DOCKETED	
Docket Number:	11-AFC-04
Project Title:	Rio Mesa Solar Electric
TN #:	233568
Document Title:	Applicant's Supplemental Response to Data Request 16 and 26 Additional Information Regarding Alternatives
Description:	Document was on proceeding webpage and is now moved over to the docket log.
Filer:	Marichka Haws
Organization:	California Energy Commission
Submitter Role:	Commission Staff
Submission Date:	6/19/2020 3:45:24 PM
Docketed Date:	6/19/2020

APPLICANT’S SUPPLEMENTAL RESPONSE TO DATA REQUEST 16 AND 26: ADDITIONAL INFORMATION REGARDING ALTERNATIVES

**OFF-SITE ALTERNATIVES
RIO MESA SOLAR
ELECTRIC GENERATING FACILITY**

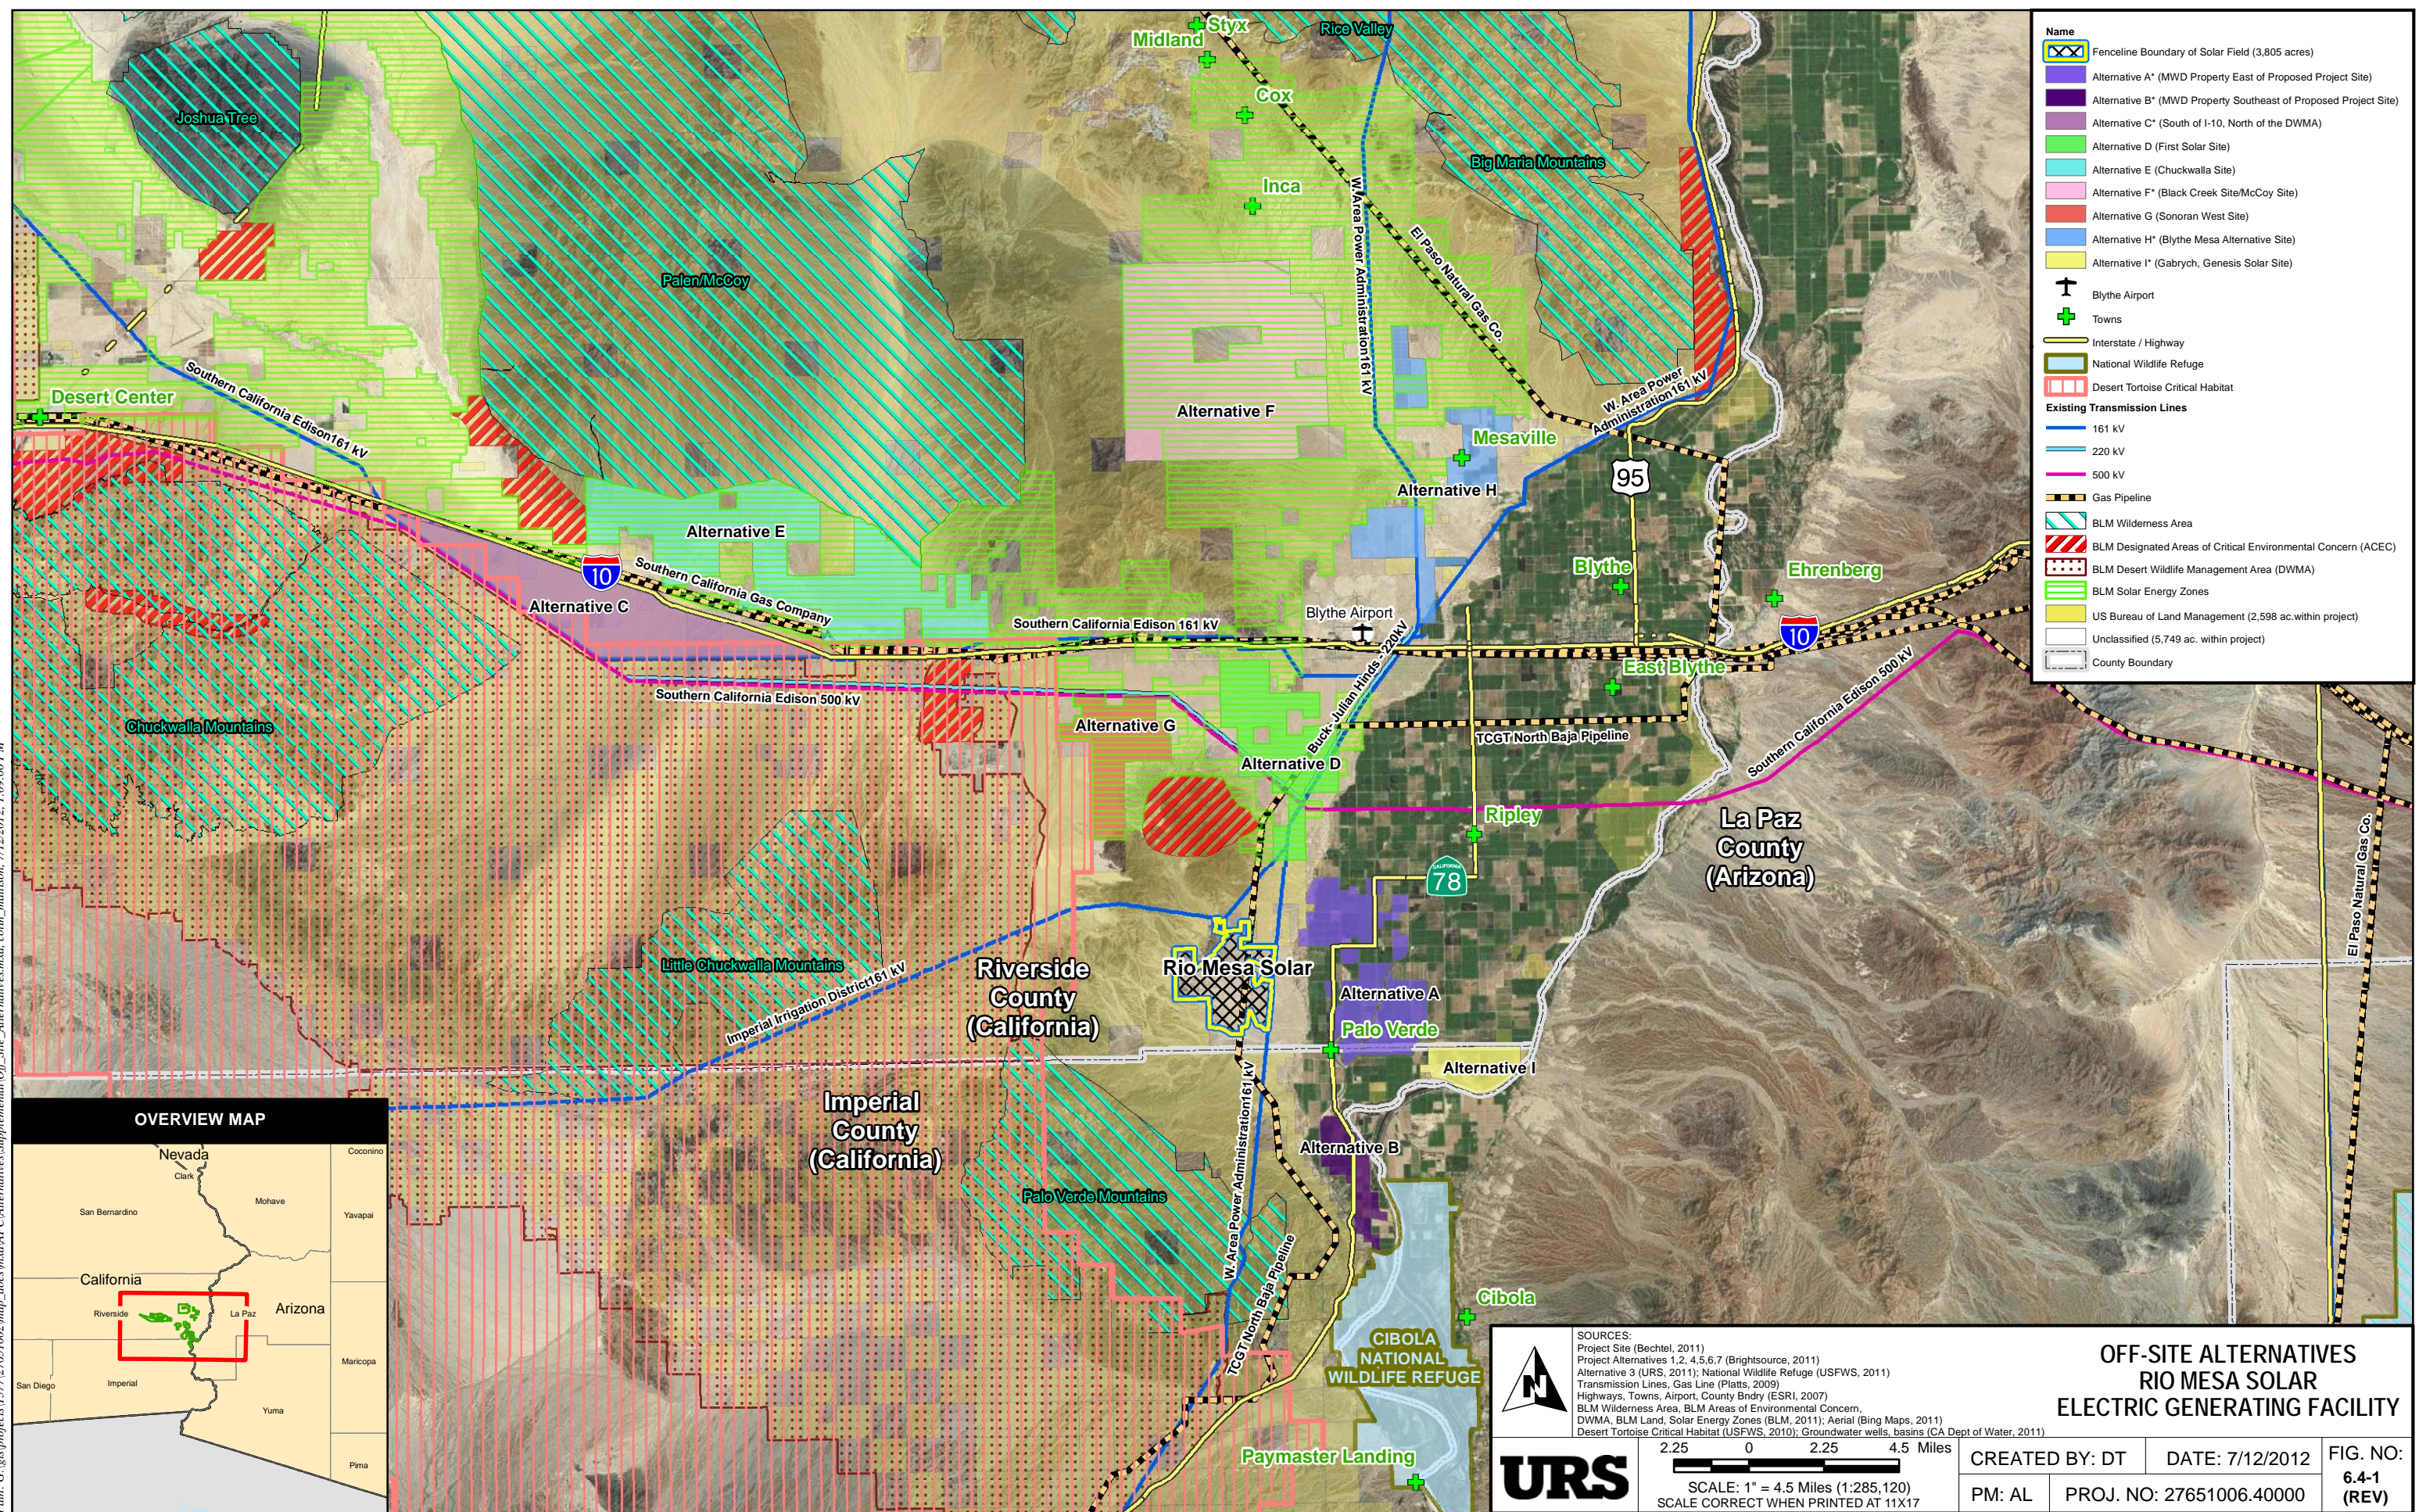
- **Off-Site Project Alternatives:** Nine off-site alternatives identified in Section 6.4.1 are evaluated for feasibility using project screening criteria identified in Section 6.4.2 and shown on Figure 6.4-1 [\(rev\)](#). Seven of the nine off-site alternatives were considered but ultimately rejected from further consideration because development of a solar generating facility that attains most of the project objectives is not considered feasible from a technical or economic standpoint on any of these sites as demonstrated in Section 6.4.3. Development of a solar generating facility that attains most of the project objectives is considered feasible from a technical and economic standpoint for two of the nine off-site alternatives. These two off-site alternatives are carried forward for detailed alternatives analysis in Section 6.4.4.
